The enclosed Traffic Impact Study (TIS) review letter for the proposed **First State Crossing** (Tax Parcels: 06-048-00-001, 06-059.00-162, 06-072.00-198, 06-073.00-001) mixed-use development has been completed under the responsible charge of a registered professional engineer whose firm is authorized to work in the State of Delaware. They have found the TIS to conform to DelDOT's Development Coordination Manual and other accepted practices and procedures for such studies. DelDOT accepts this letter and concurs with the recommendations. If you have any questions concerning this letter or the enclosed review letter, please contact me at Annamaria.Furmato@delaware.gov.

RE: Agreement No. 1946F
Traffic Impact Study Services
Task No. 4A Subtask 05 – Addendum #2 to First State Crossing TIS

McCormick Taylor has completed its review of Addendum #2 of the Traffic Impact Study (TIS) for the First State Crossing mixed-use development, prepared by Traffic Planning & Design, Inc. (TPD). The original TIS was dated June 2019 and was updated in August 2019, Addendum #1 was submitted in February 2020, and Addendum #2 is dated September 2022. TPD prepared the Addendum #2 report in a manner general

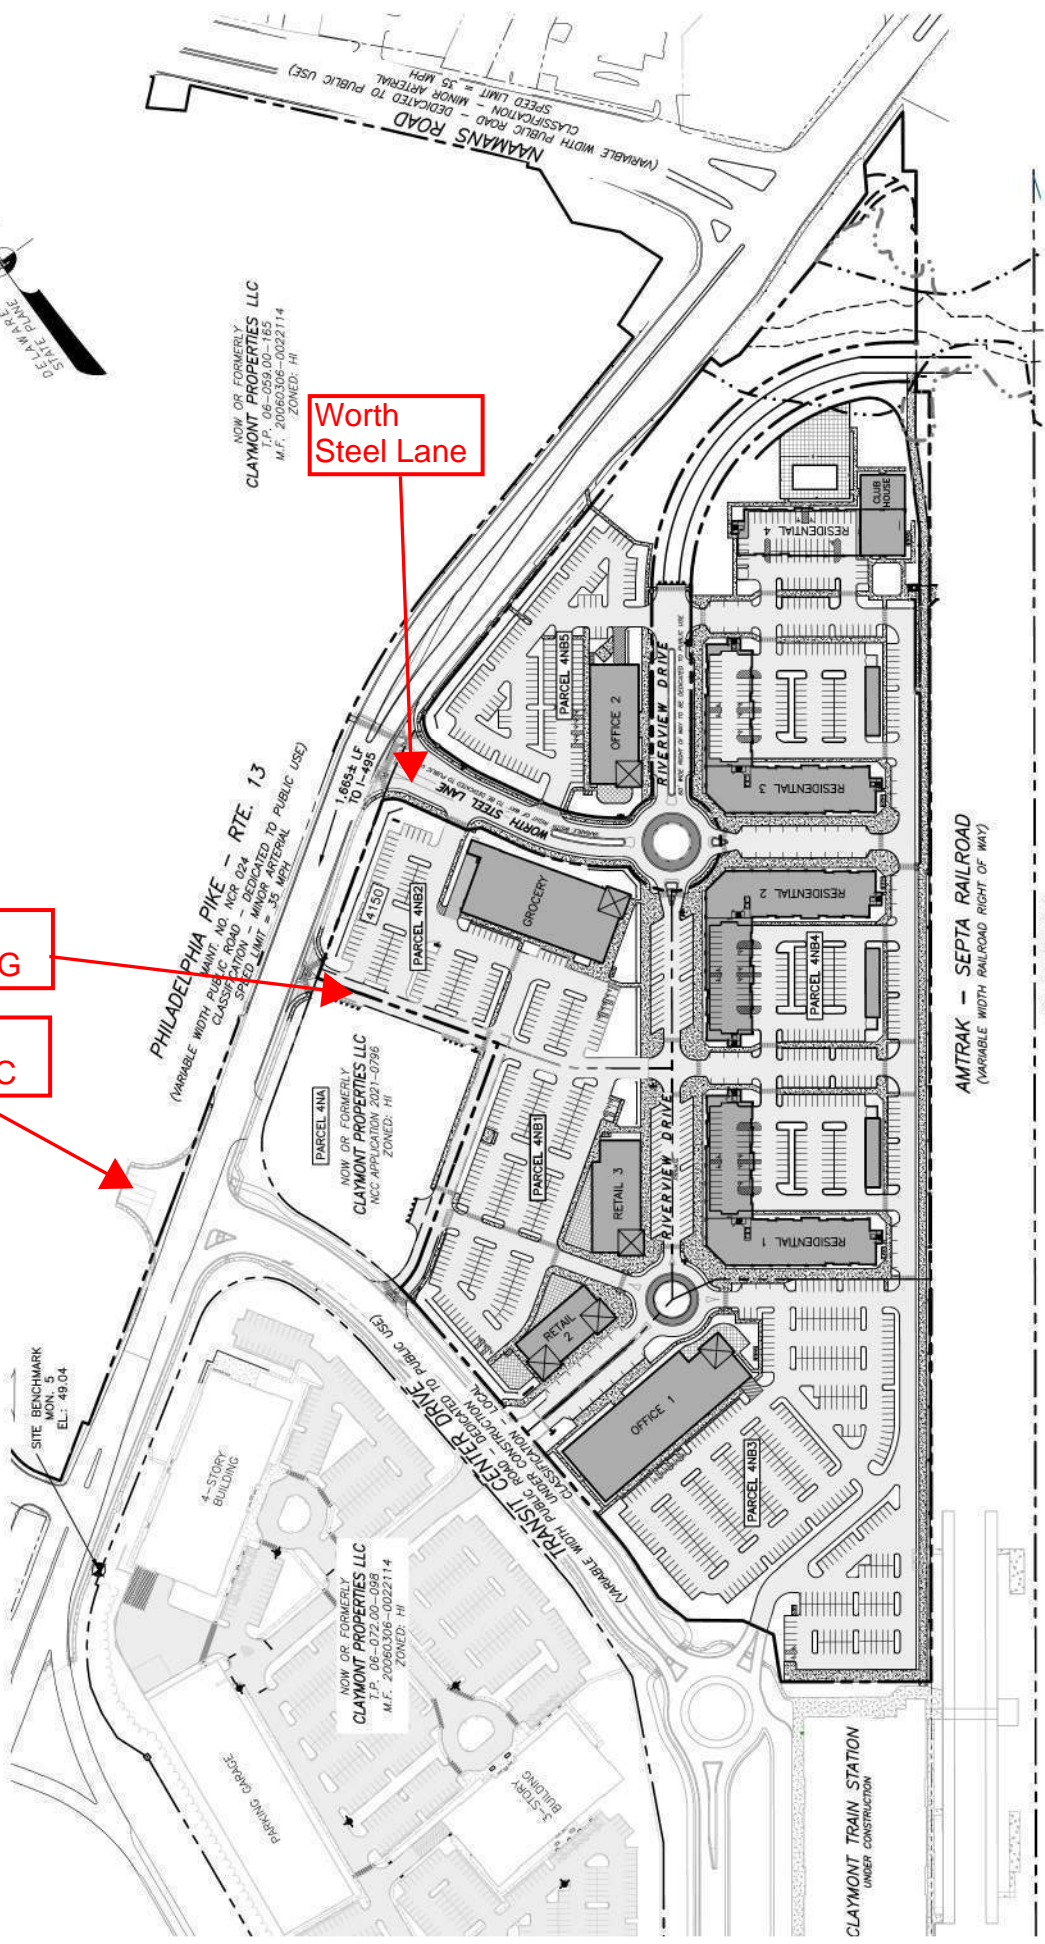
An updated site plan for Site Parcel 4 (Phase 1) was provided in Addendum #2 and is included on page 3 of this review letter. Site Parcel 4 lies east of Philadelphia Pike but west of the AMTRAK/SEPTA rail lines. Based on plans in the original TIS, Site Parcels 1 and 3 (not shown on the updated Addendum #2 site plan) are located west of Philadelphia Pike and south of Naamans Road, while Site Parcel 6 (also not shown on the updated site plan) is located east of the AMTRAK/SEPTA rail lines with a roadway connection through Site Parcel 4 to access Philadelphia Pike. The site plan from Addendum #1, which showed all the site parcels, is provided on page 16 of this Addendum #2 letter for reference to the locations of all site parcels. It is important to note the Addendum #1 site plan shows the possibility of a Spine Road across Naamans Creek (connecting Site Parcels 1 and 3) but that is no longer being considered.
